**From:** Detterman, Mark, Env. Health  
**Sent:** Friday, March 15, 2013 5:25 PM  
**To:** 'Bob Clark-Riddell'  
**Cc:** jerlich@albanyca.org; Tony Kershaw; Drogos, Donna, Env. Health; Roe, Dilan, Env. Health  
**Subject:** FW: 1187 Solano - Grading Permit  
**Attachments:** Fig 2 Site Map.pdf; Fig 3 PCE in Subslab Soil Gas.pdf; Fig 11 Excavation Extent.pdf; PCE in Soil 5 to 8 ft depth.pdf; Subslab Venting Layout.pdf; excavation sequence drawing-rev.pdf

Re: **1187 Solano Avenue**  
**Soil Remediation**  
Albany, CA  
Excavation Plan

**1187 SOLANO AVENUE  
 ALBANY, CA  
 SOIL REMEDIATION  
 EXCAVATION PLAN**

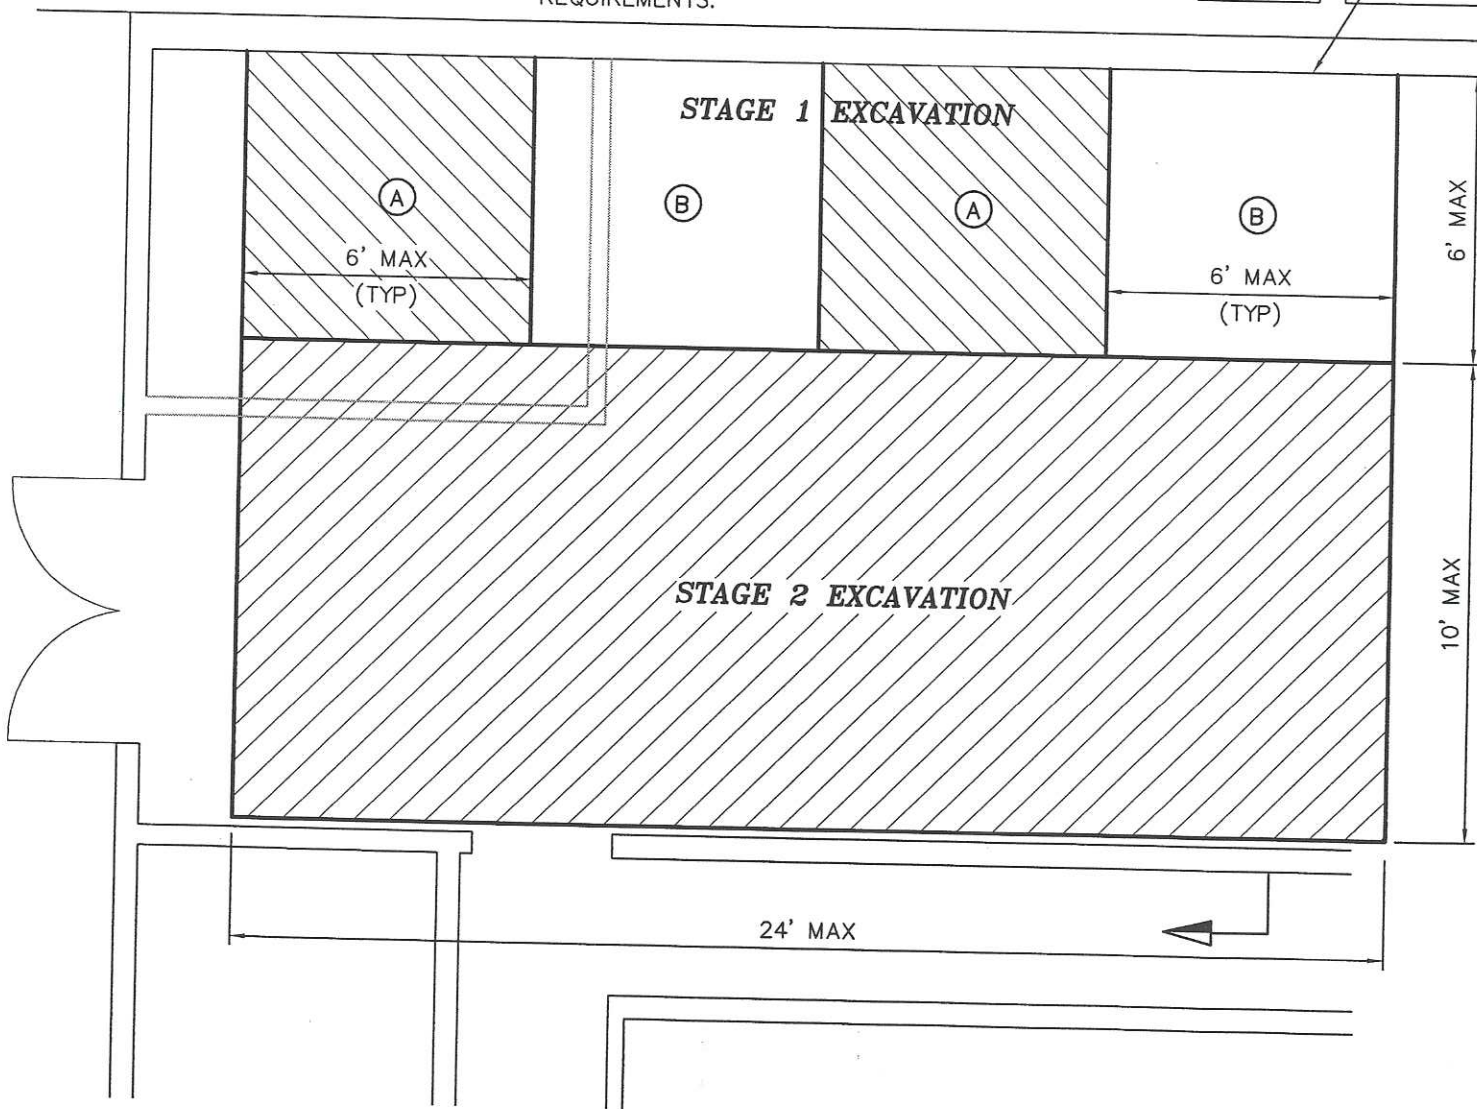
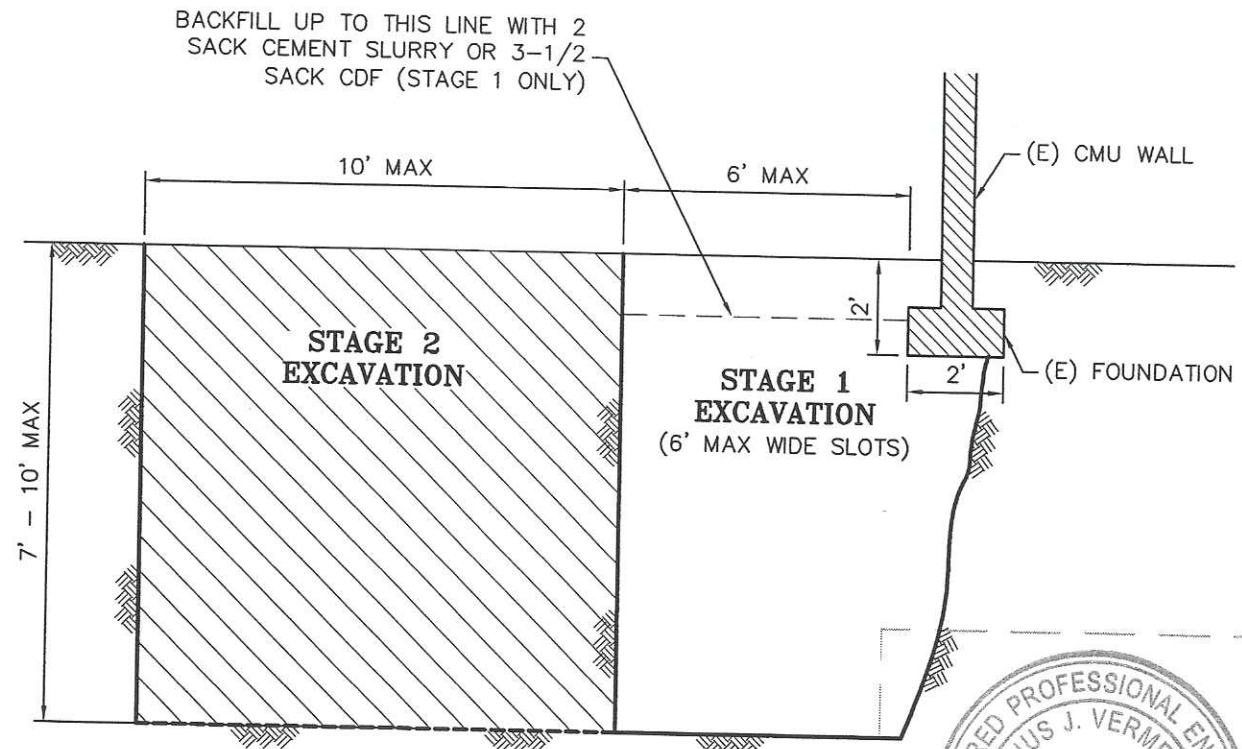
**This letter serves to address the following requests from Pangea Environmental Services:**

1. To widen the Stage 1 slots from 4' to 6' max.
2. To clarify the acceptable backfill.
3. To combine Stage 2 and Stage 3 excavations.
4. To use 3-1/2 sack CDF for the backfill of Stage 1 excavation in lieu of 2 sack cement slurry as stated in the Excavation Plan.

1. Due to the conditions of the site it is acceptable to widen the Stage 1 slots to a maximum of 6'.
2. Crushed rock is an acceptable backfill material provided compaction via vibration equipment is used at approximately 4' lifts. Verify backfill & compaction requirements with the City of Albany Standards or Geotechnical requirements.
3. It is acceptable to combine Stage 2 and Stage 3 excavations provided the maximum excavation depth does not exceed 10'.
4. It is acceptable to use 3-1/2 sack CDF that meets EBMUD specifications in lieu of 2 sack cement slurry.

The excavation plan drawings have been revised to reflect these changes.
